DESIGN INTEGRITY PANEL RESPONSES

DESIGN INTEGRITY PANEL

B02-05

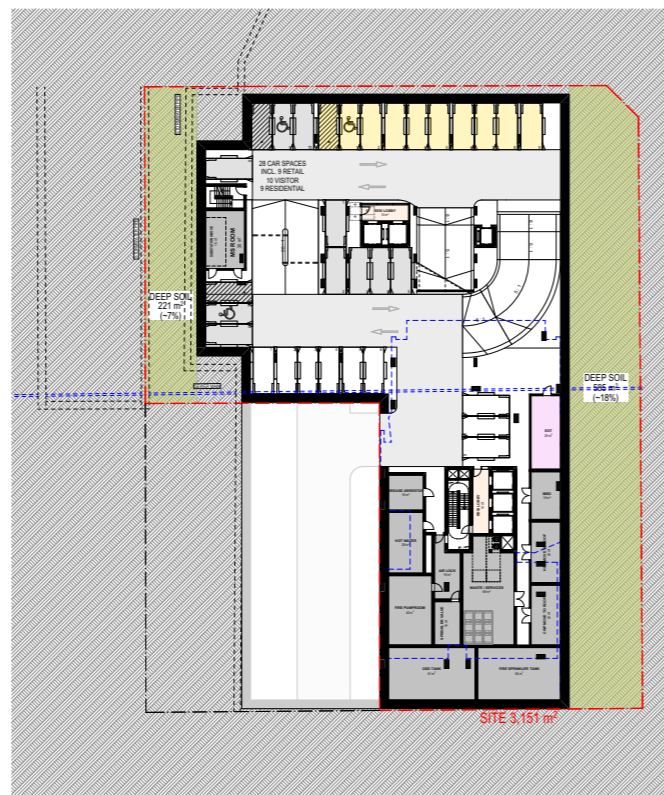
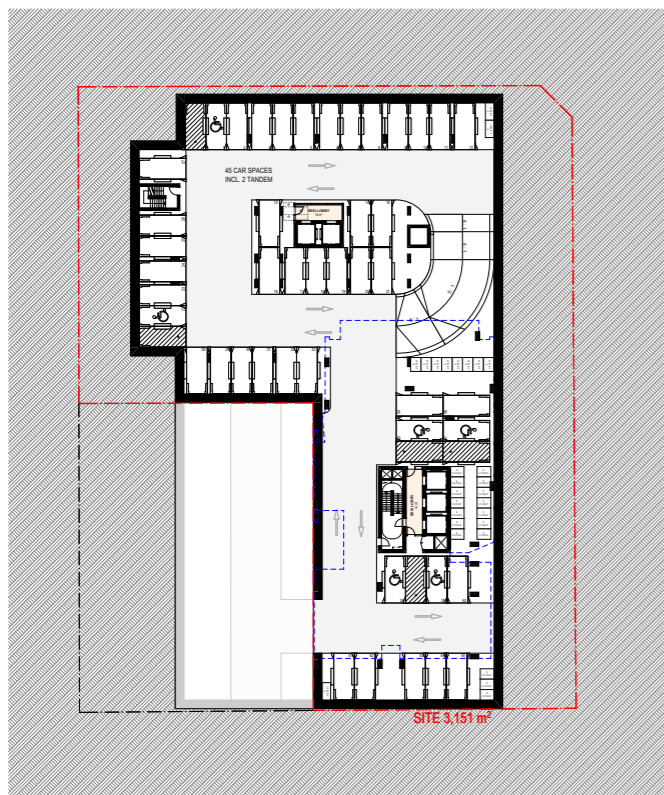
Further development of loading, basement and carparking design, and the treatment of underground sewer and stormwater infrastructure is required, ensuring alignment with technical objectives and constructability.

Improved Circulation: Basement layout reconfigured to enhance vehicle movement, efficiency, and access.

Loading Dock Relocation: Ground floor loading dock repositioned, prompting ramp relocation to Basement 1 for smoother entry and exit.

Optimised Car Parking: Clearer structural grid and simplified circulation improved legibility and reduced travel distances.

Reduced Tandem Spaces: Rationalised parking layout decreased tandem bays, improved safety and user convenience.

Setback Coordination: Minor encroachments within western setback allowed for diversion and upgrading of underground services.

L00

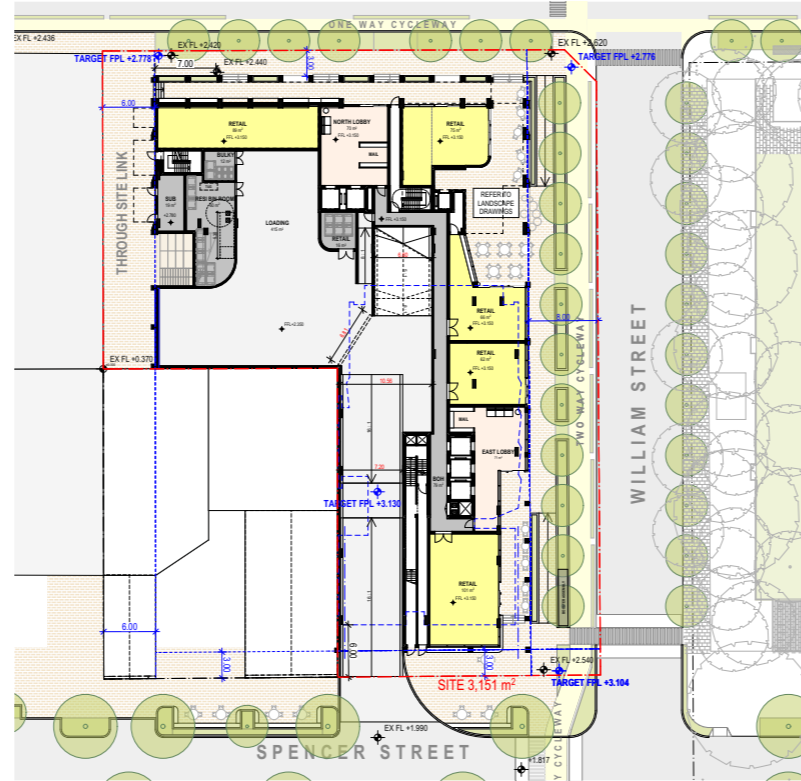
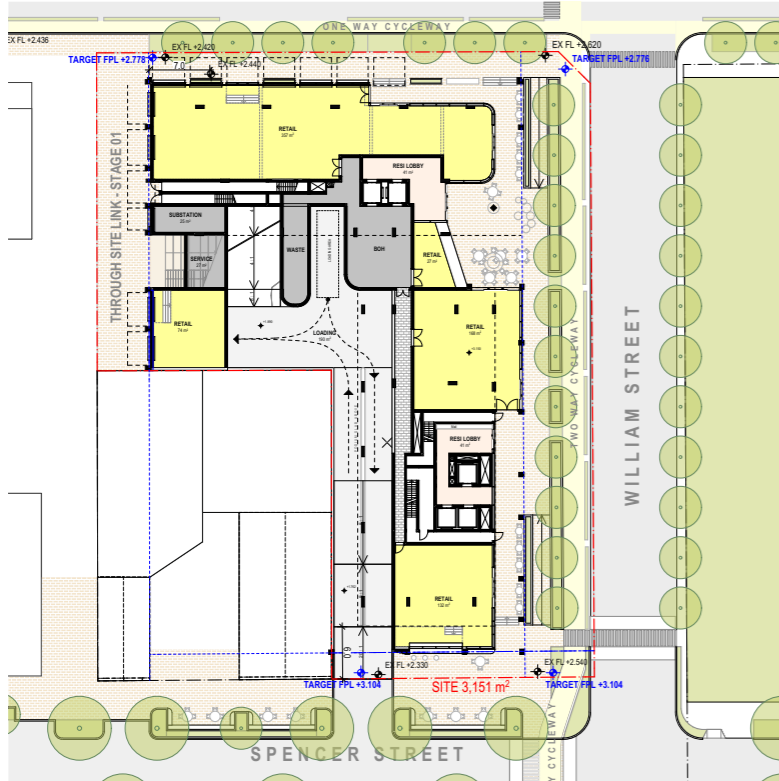
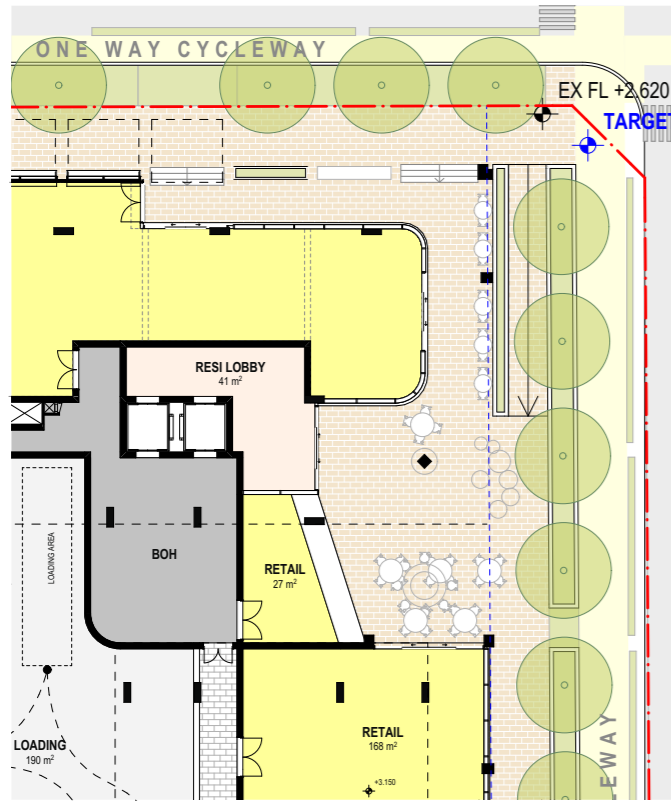
The dynamic and flexible nature of the retail offering was considered a positive, however, the Jury would expect further refinement and integration with the public domain once the retail strategy has been developed.

Queens Road Lobby

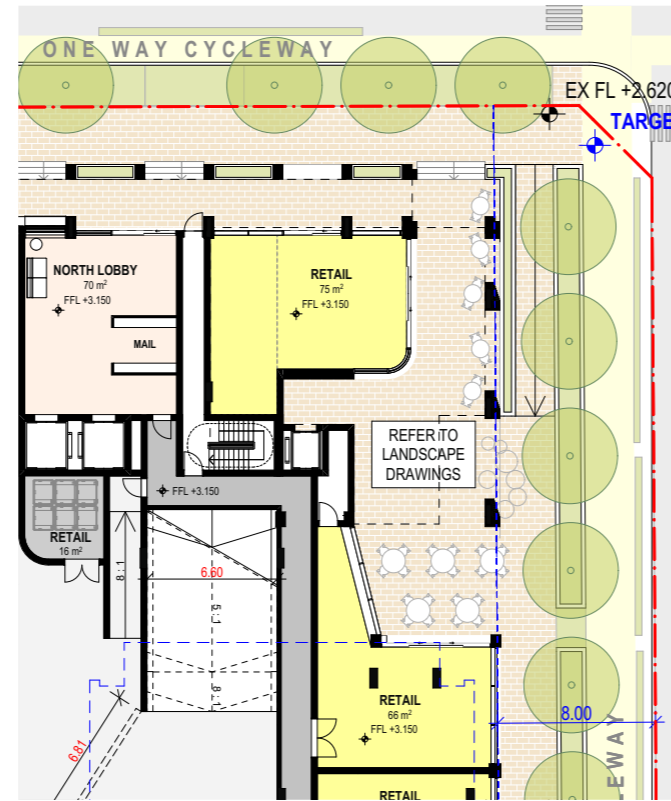
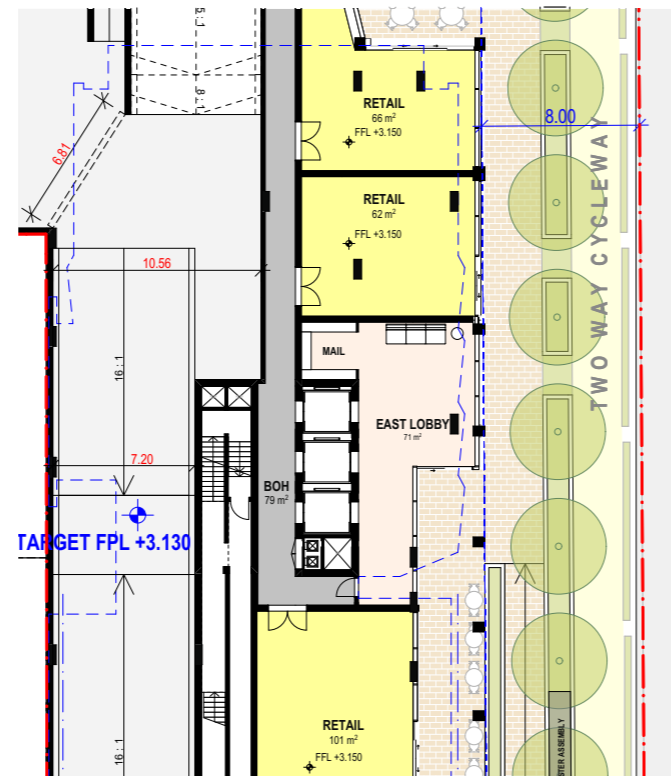
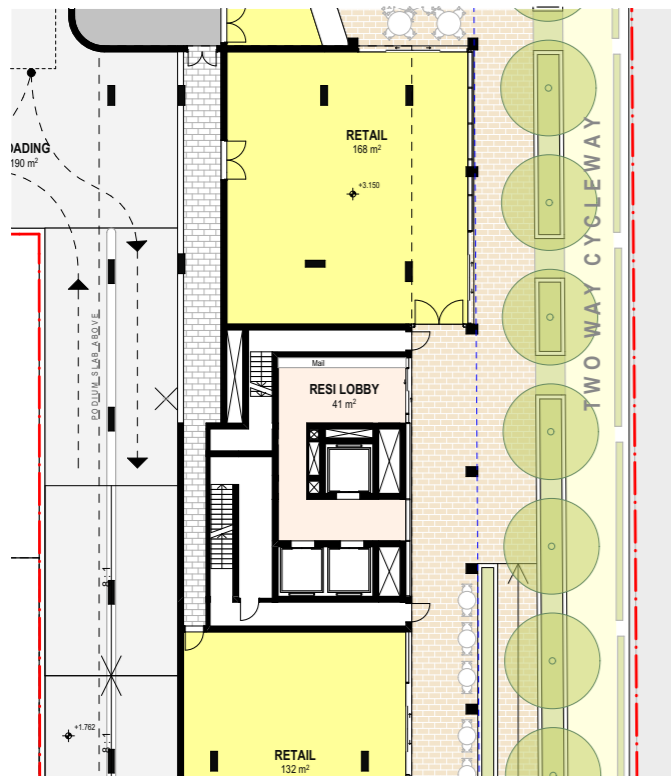
The lobby is lacking size and character given the scale of the tower and as such, it is recommended to consider the lobby with greater spatial generosity and architectural presence.

PODIUM FACADE SPLAY

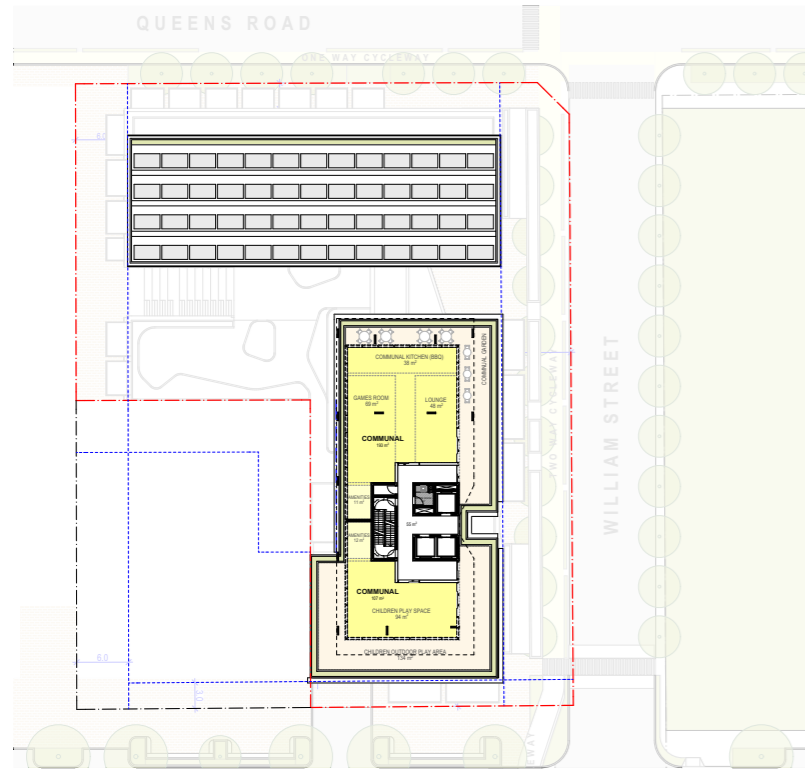
Greater solidity in the podium should be explored to improve privacy for residents.

L05

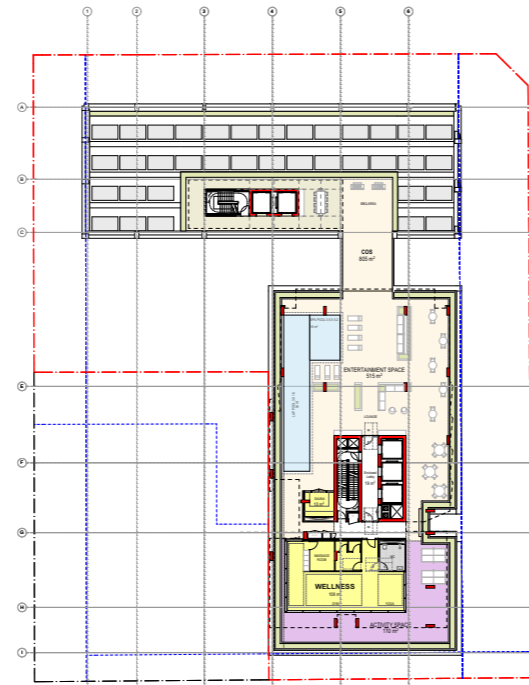
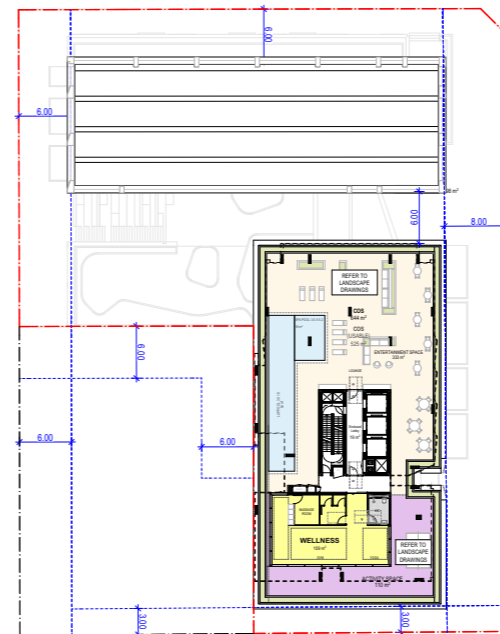
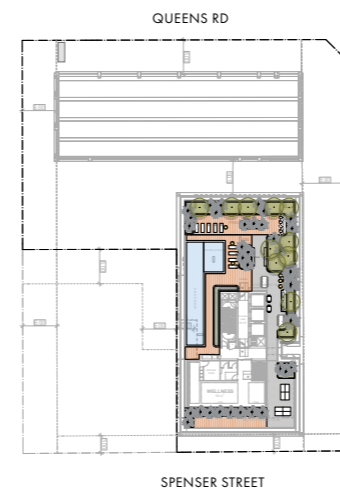
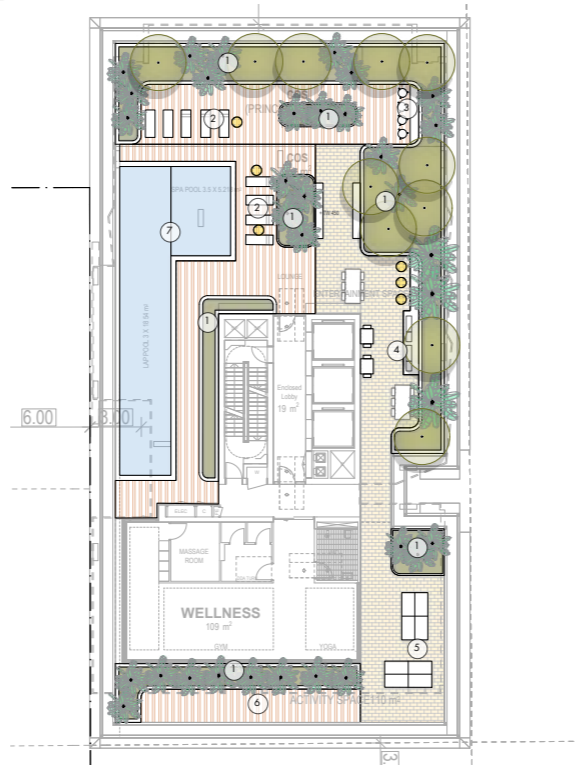
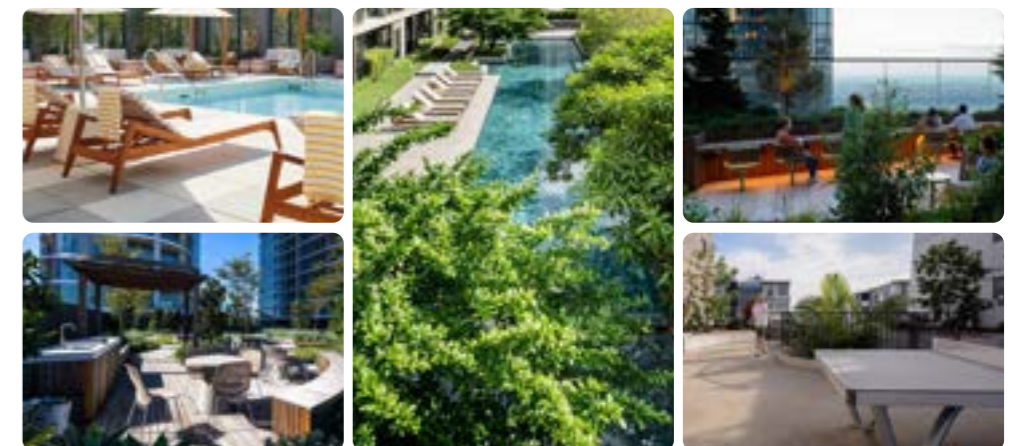
The design should investigate the potential for communal open space on the rooftop of the northern podium.

Tower

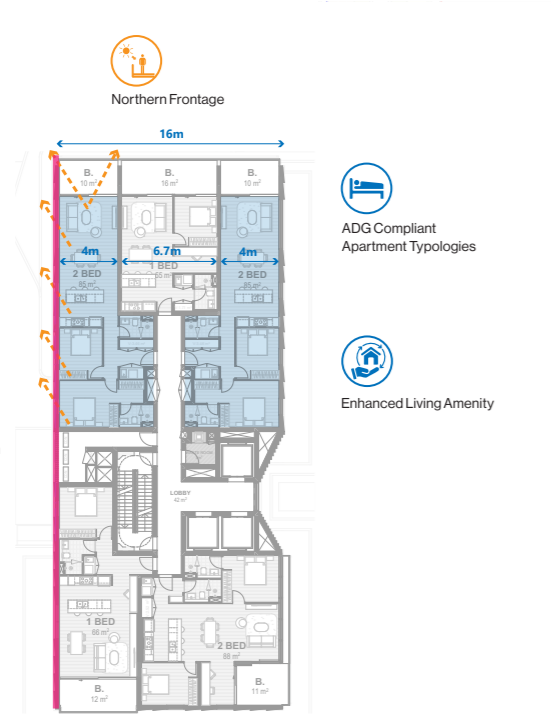
The western façade requires further development.

View West

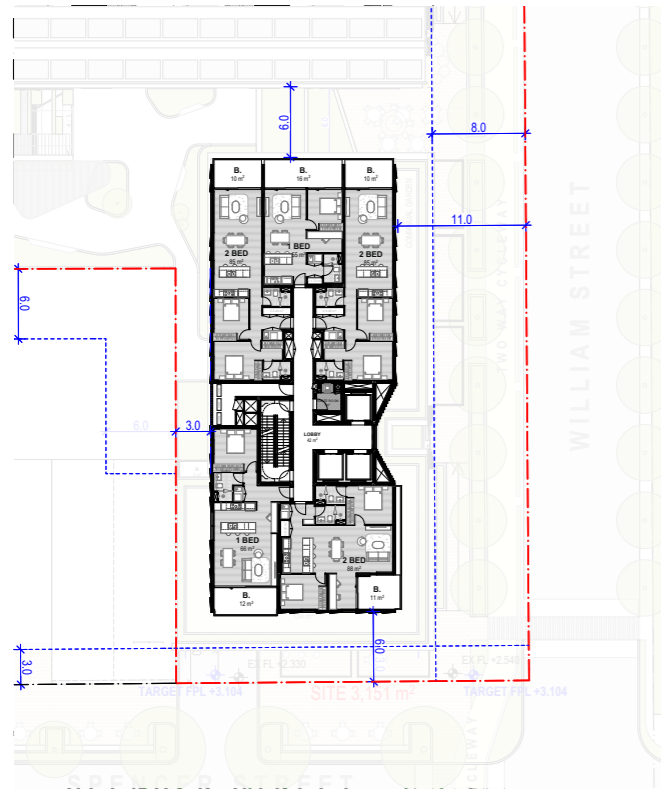
There are concerns with the effectiveness of the shallow angled façade, and its expression could be amplified to also provide a more functional purpose to create openings with a northerly aspect that provide views whilst achieving thermal comfort through balancing solar access and sun shading.

Enhanced Façade Modulation: Deeper projections and clearer vertical rhythm improved architectural expression and identity.

Optimised Solar Performance: Increased façade depth and refined window placement balanced solar access and shading for better thermal comfort.

Improved Outlook & Amenity: Reoriented openings and balconies captured northern views toward the park and Parramatta River.

Refined Apartment Planning: Enhanced corner layouts and more dual-aspect dwellings improved livability, daylight, and overall market appeal.

SETBACKS

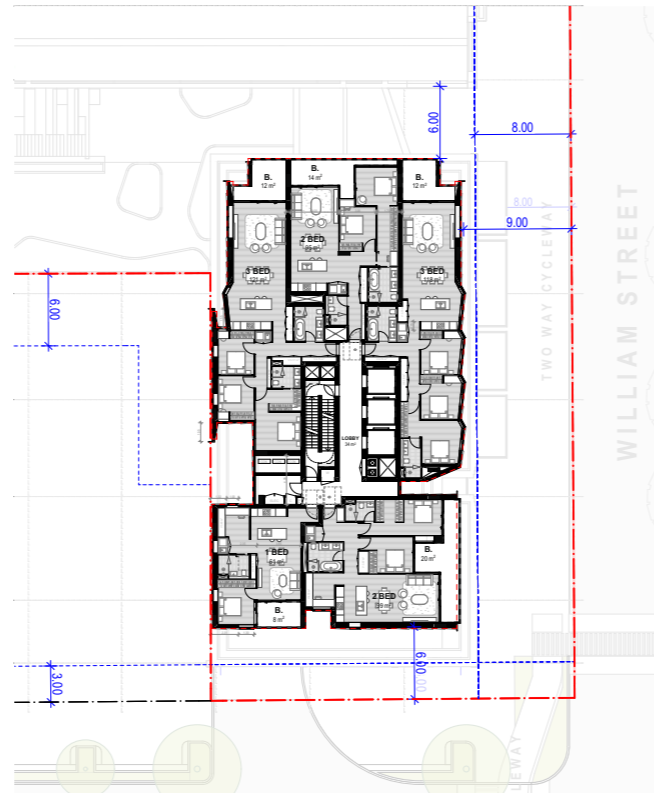
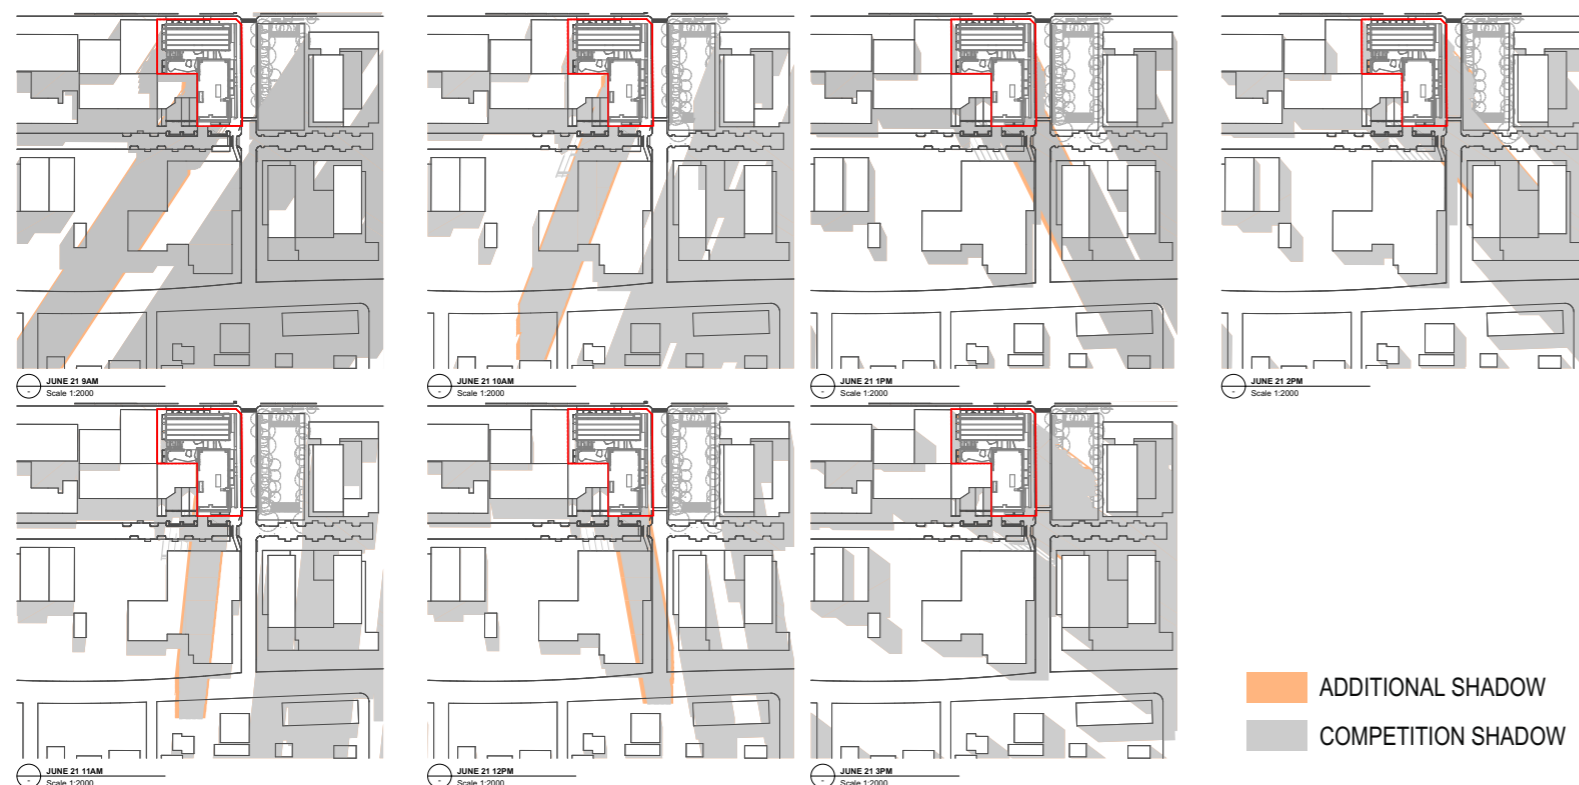
Subject to support from the consent authority, support is given to exploring encroachment into setbacks, particularly to the east and west, where this offers opportunity to improve residential amenity and building articulation, provided it does not result in adverse impacts on the surrounding development, does not result in blank walls and can still comply with the relevant NCC standards. One potential area to investigate this would be to reconfigure the south-eastern apartment so that the balcony wraps around the lift core (within the setback) and makes better use of the premium eastern façade, which offers views to the park and Sydney Harbour. It is important that any change maintains the strong verticality of the eastern façade and does not have significant adverse overshadowing impacts.

Deepened Façade Geometry: Enhanced articulation improved solar access, daylight penetration, and visual depth while strengthening market appeal.

Setback Encroachments: Selective projections into eastern and western setbacks maximised northern aspect, improved apartment outlook, façade modulation, and spatial efficiency with better structural alignment and negligible overshadowing impact.

South-Eastern Balcony Reconfiguration: Balcony extended to capture premium park and river views, enhanced amenity and reinforced the façade's vertical rhythm.

Improved Apartment Planning: Increased dual-aspect dwellings and optimised layouts enhanced livability and overall residential value. Boutique layouts offered greater flexibility and individuality compared with the more standardised, "box-like" configurations of the adjacent Deicorp development. Refined scheme increased the proportion of 3-bedrooms dwellings, catering to downsizers and intergenerational families.
